KSM Open Pit Design Review

June 12, 2012
Project No: 0683-013-30

Re: KSM Project 2012 Pre-Feasibility Study Update - Open Pit Design Review

PROJECT: KSM PROJECT 2012 PRE-FEASIBILITY STUDY UPDATE OPEN PIT DESIGN REVIEW		
TITLE: SULPHURETS PIT OVERVIEW		
PROJECT No.:	DWG No.:	REV.:
0638-013-30	02

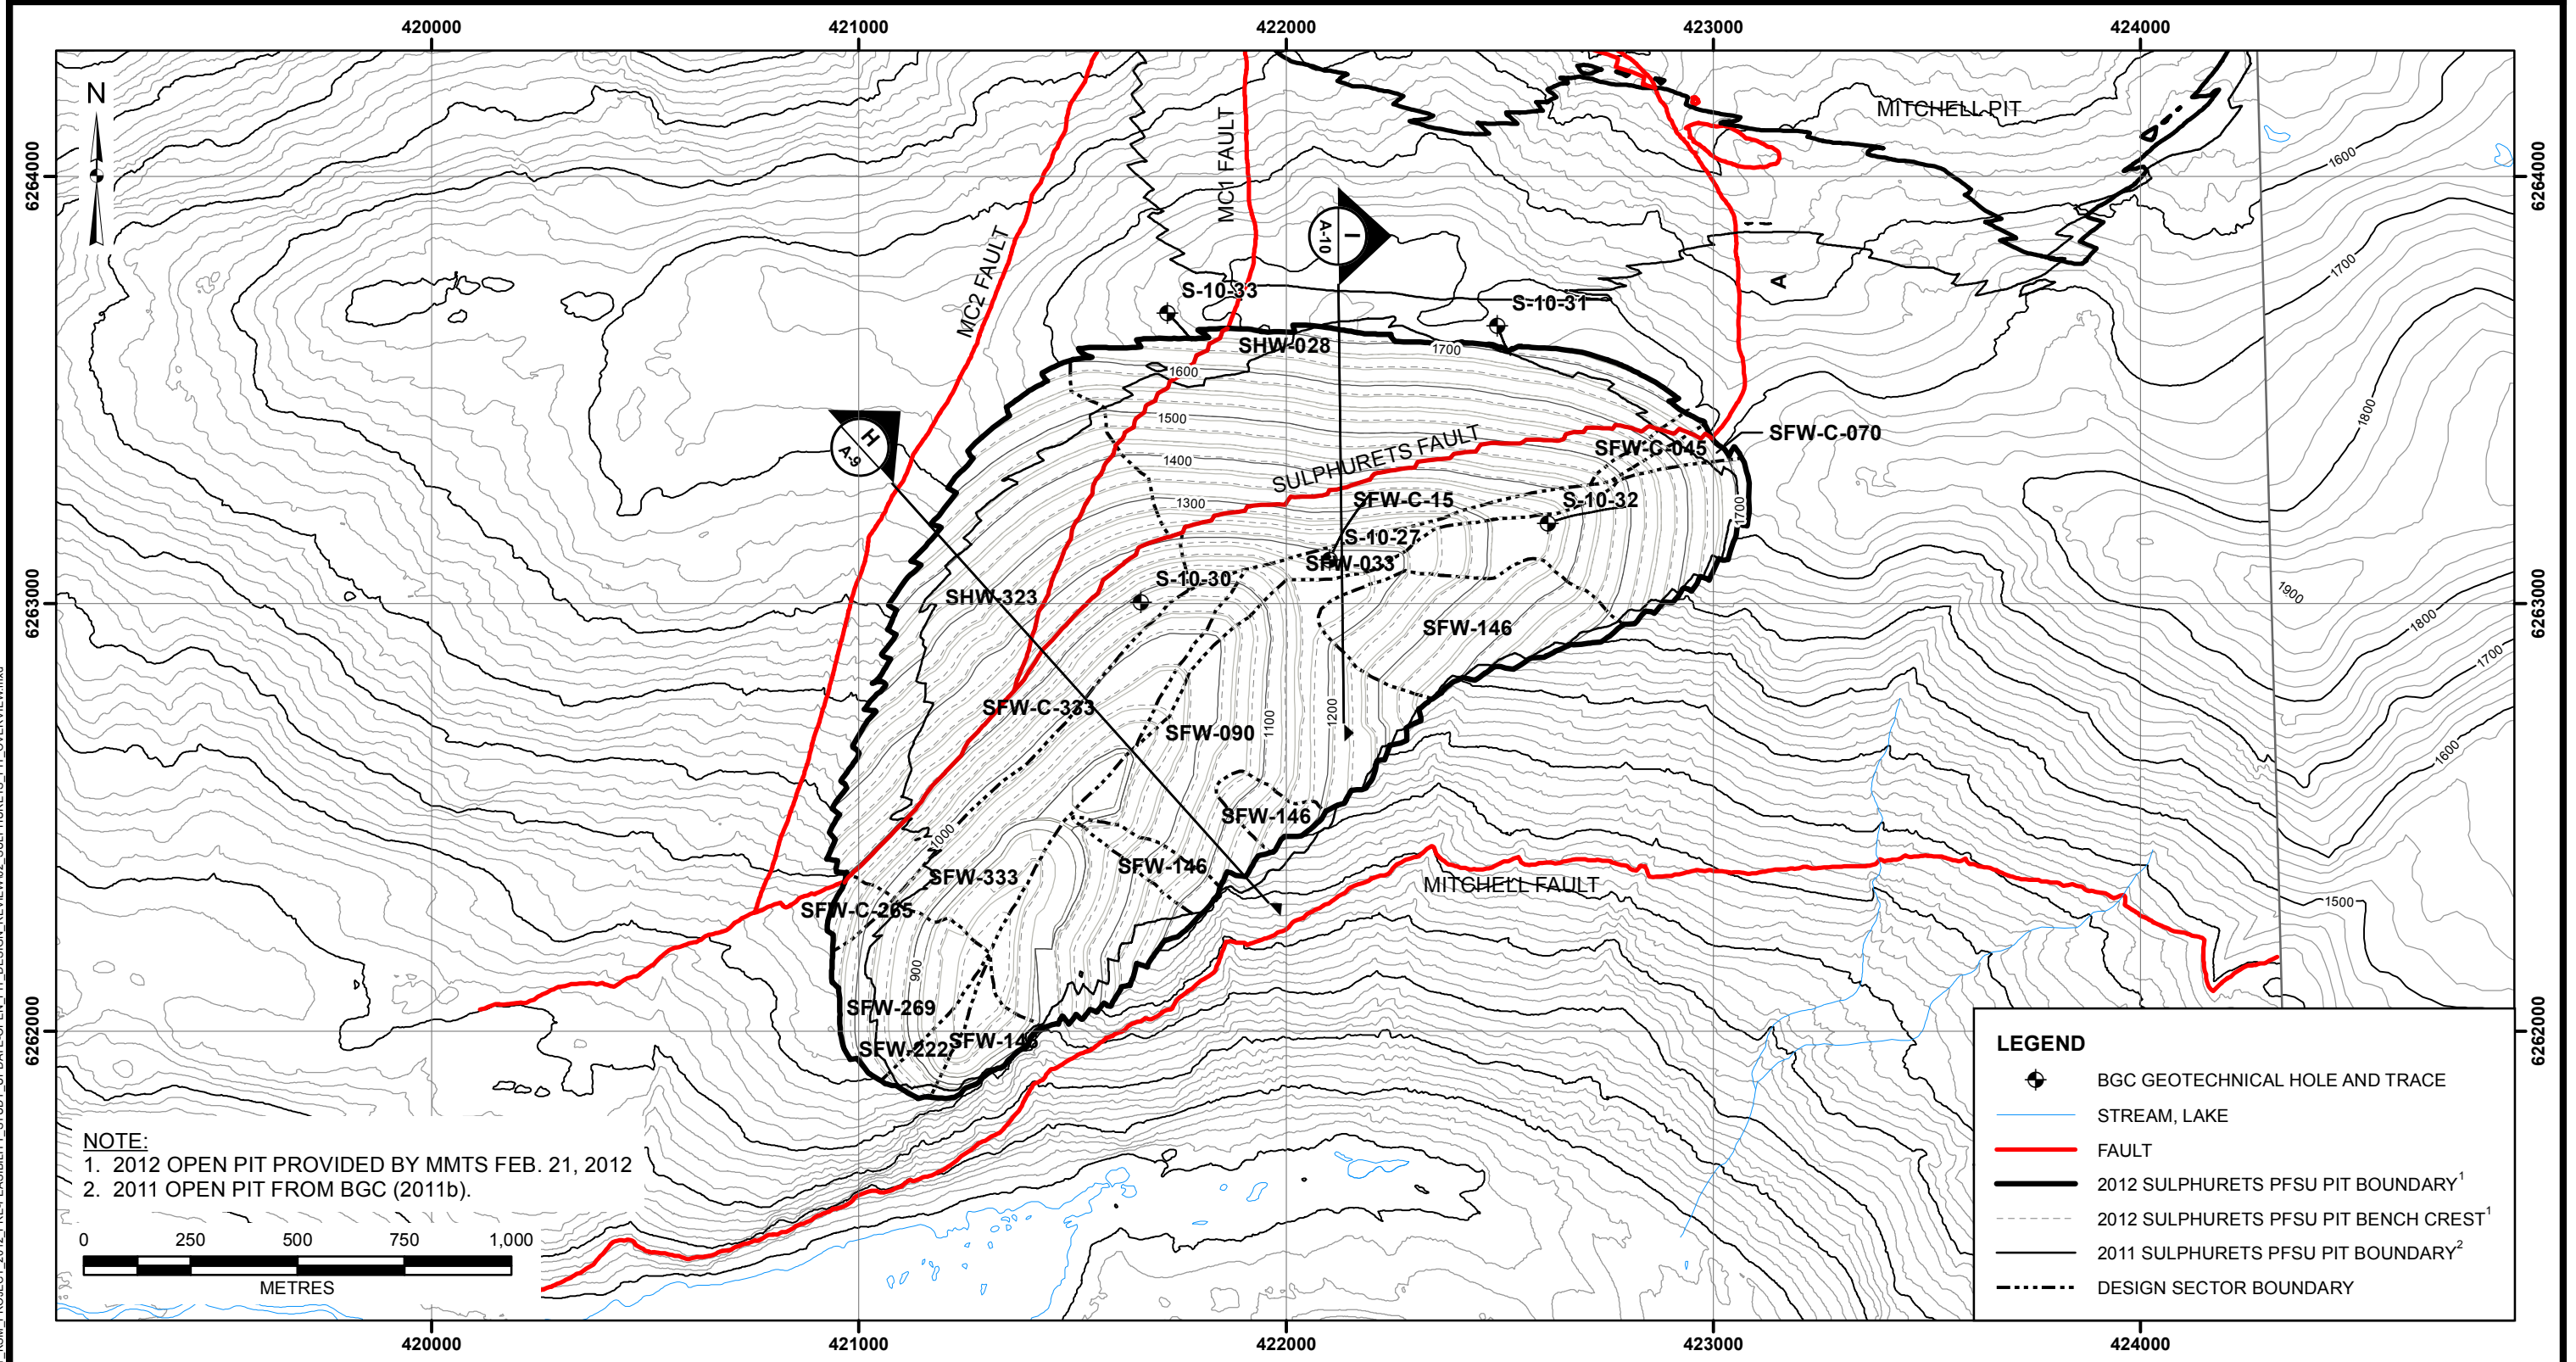
The Sulphurets zone is located near the top of the Mitchell-Sulphurets ridge, directly south of the Mitchell zone, and upslope of Sulphurets Lake. The maximum slope heights of the proposed ultimate pit reach approximately 600 m. The footprint and geometry of the proposed Sulphurets pit has only changed slightly from the open pit from the 2011 PFSU (Drawing 2).

The initial review of the S682 ultimate pit provided to BGC on February 15, 2012, "KSM - Sulphurets Ultimate Pit S682.dxf" identified two sectors of the pit where the recommended inter-ramp / interberm slope angles were exceeded: design sectors SFW-269 and SFW-146. In addition, Domain SFW-090 contained a 60 m high unbenched slope forming a "quadruple bench". BGC communicated the results of this review to MMTS by email on February 20, 2012. Based on this review, MMTS developed an updated ultimate pit, "Sulphurets series 9 ultimate 21Feb2012.dxf" which was provided to BGC on February 21, 2012. This updated ultimate pit (Drawing 2) meets all of the geometrical requirements included in BGC's geotechnical slope design recommendations (BGC, 2011b).

PROJECT: KSM PROJECT 2012 PRE-FEASIBILITY STUDY UPDATE OPEN PIT DESIGN REVIEW		
TITLE: KERR PIT OVERVIEW		
PROJECT No.:	DWG No.:	REV.:
0638-013-30	03

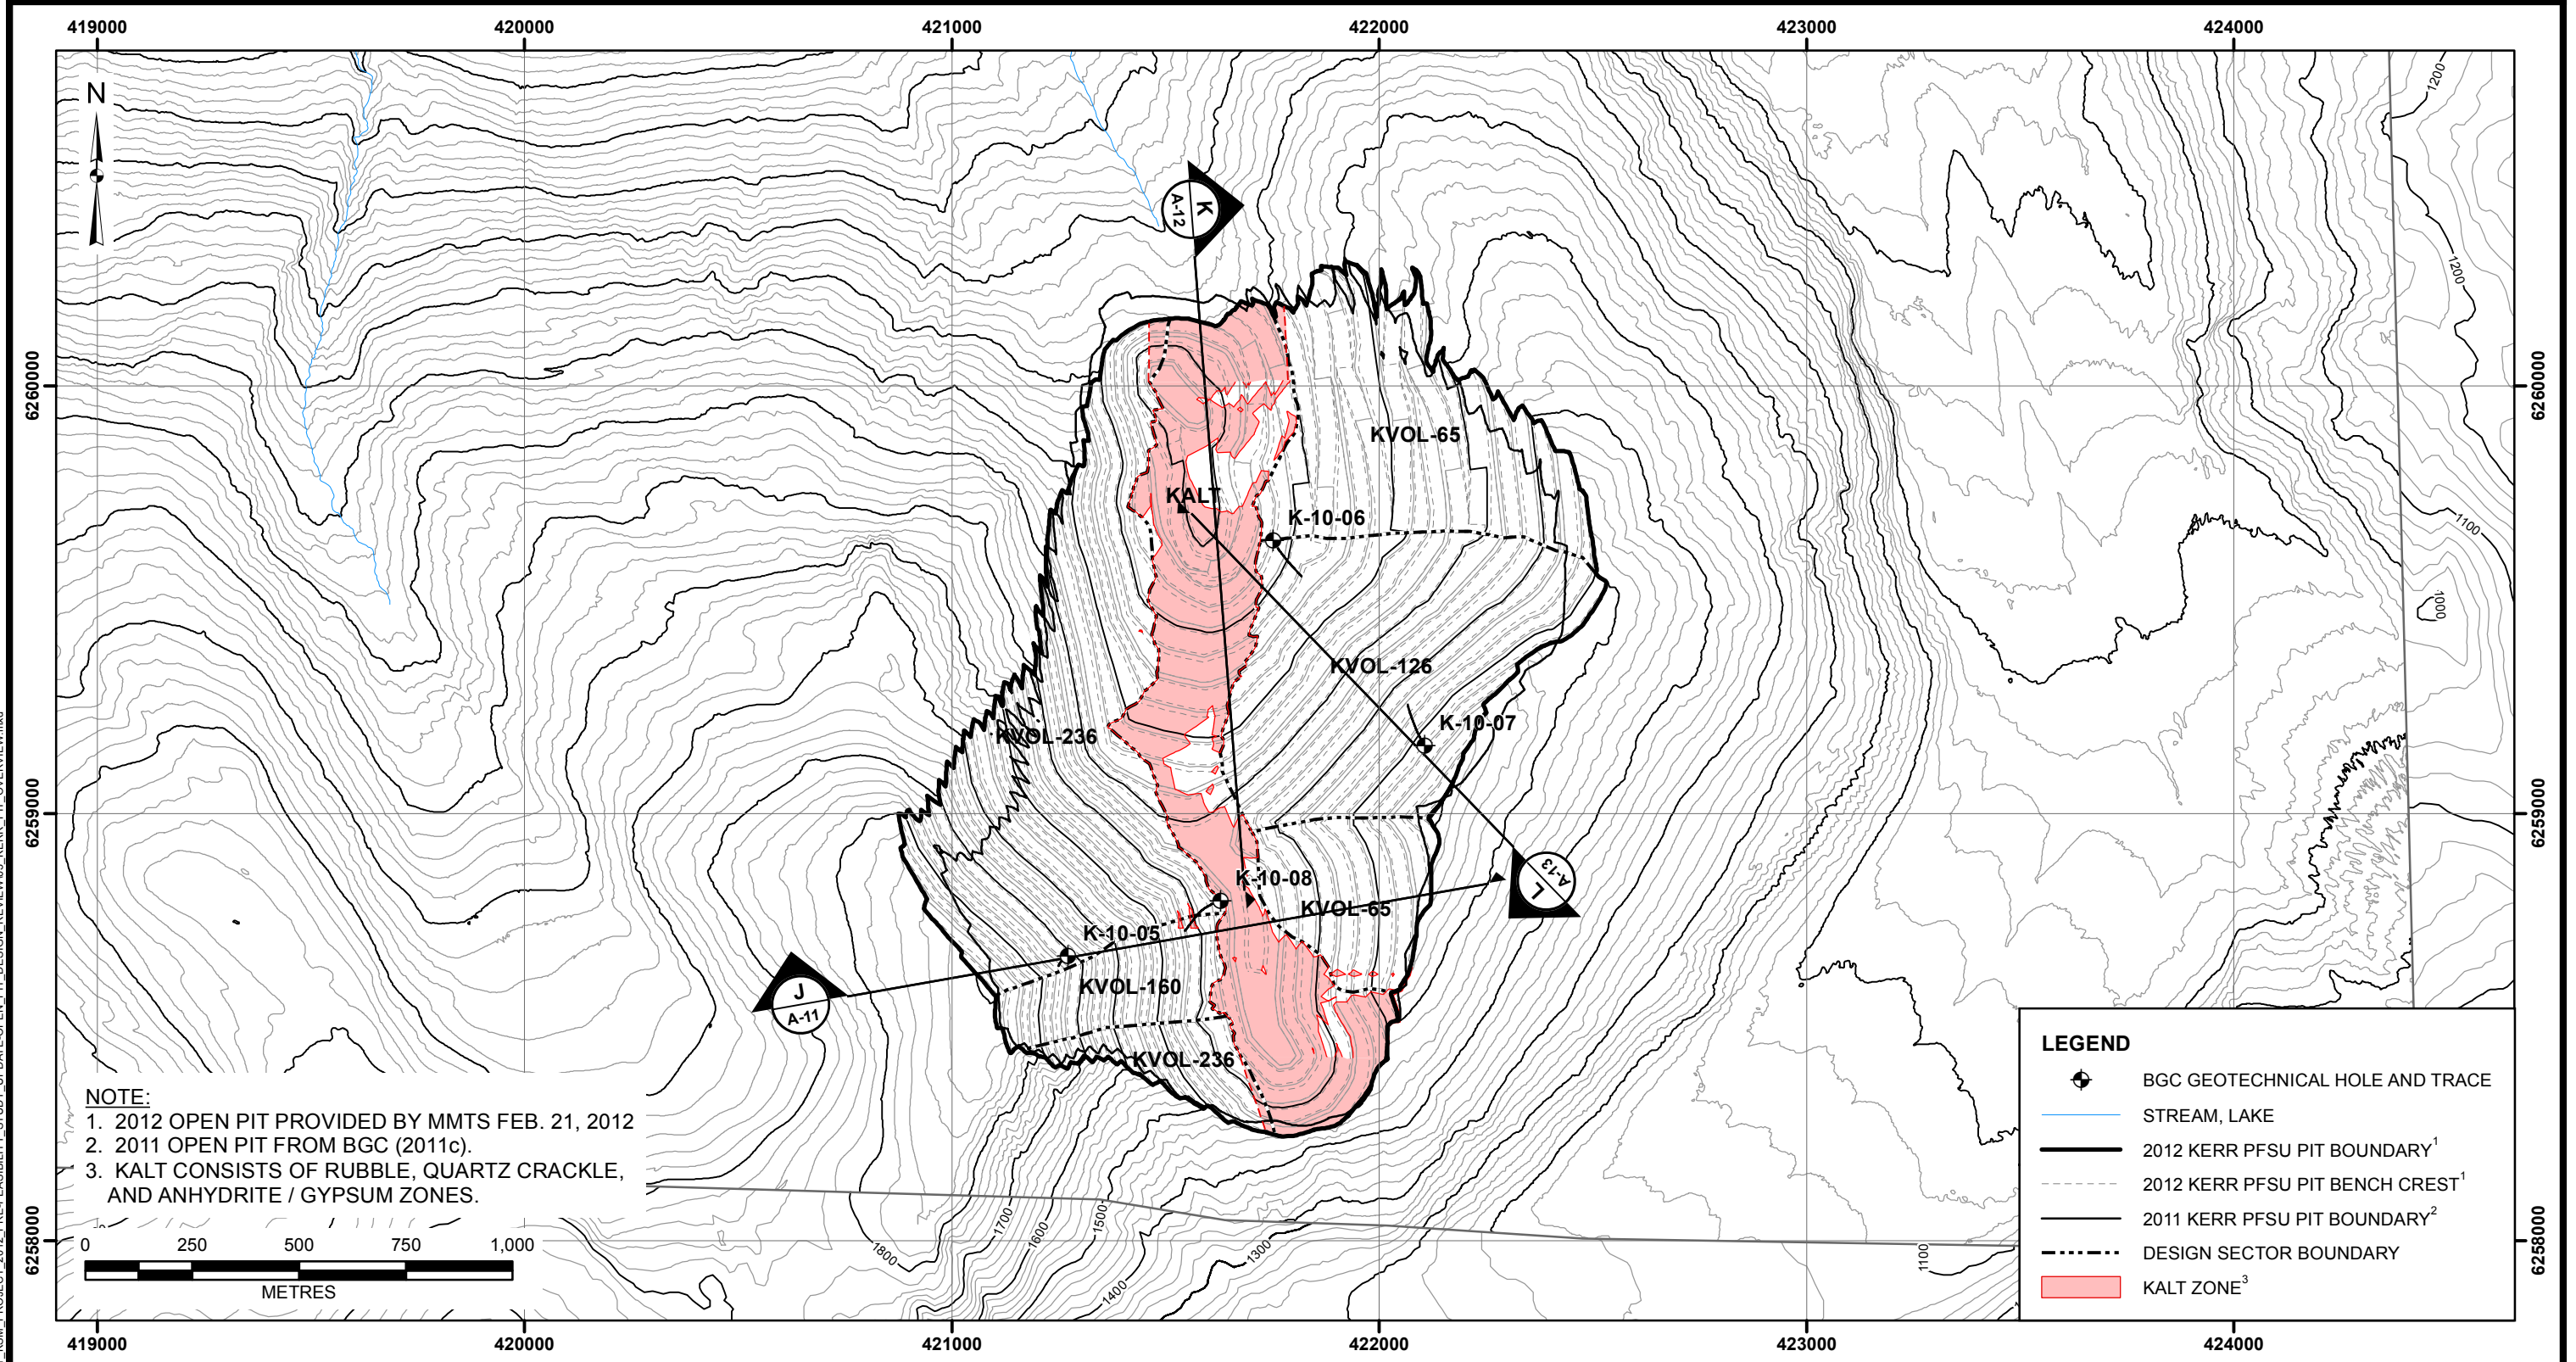
The Kerr zone is located at the top of the south slope of the Sulphurets Valley, south of the Sulphurets zone and upslope from Sulphurets Lake and the Sulphurets Glacier. A landslide has developed in the highly altered rocks below the Kerr zone. The maximum proposed slope heights for the open pit are approximately 600 m. The footprint and geometry of the proposed 2012 PFSU Kerr Open Pit are very similar to the 2011 PFSU open pit design (Drawing 3).

A review of the open pit was completed for the K691 ultimate pit (Drawing 3), "K691.dxf" provided to BGC on February 28, 2012. BGC confirmed that the slope design criteria developed by BGC (2011c) were followed. BGC communicated the results of this review to MMTS by email on March 5, 2012.
